Answers to the written questions on the second Finnish National Report on Nu- clear Safety Convention

The Finnish report on nuclear safety - Finnish 2nd national report as referred to in article 5 of the convention on nuclear safety

The number of inspections and given remarks in 1993-2001.

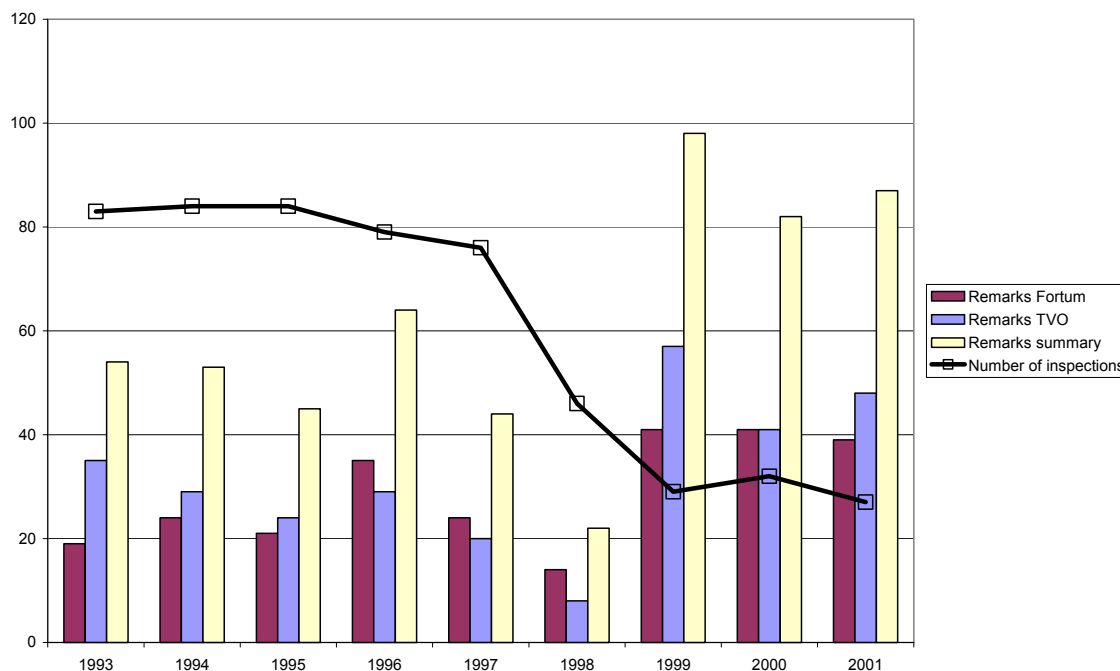
Question/comment: The report addresses that periodic inspection program for nuclear power plants was renewed during 1998 and inspections in 1999 were conducted according to the new program consisting of 30 inspections altogether.

Results of the inspection programme 1999-2001

The following picture shows the total number of inspection performed by STUK and the number of given remarks in 1993-2001. The total number of the inspections was reduced almost to one third during the renewal process of the programme in 1998 by combining inspections and targeting the inspections more to the licensee main working processes. The number of remarks has risen remarkably since 1997. One reason for the rise is that there was a relicensing and power upgrading process during 1996-1998 which took considerably regulatory resources and the STUK was not able to perform all the inspections. But also a new point of view has revealed some issues connected to management and co-operation in the licensee organization, which STUK could not see with old segmented inspection programme. Also the inspectors have been well motivated to do the new inspections, which can be seen in the inspection results.
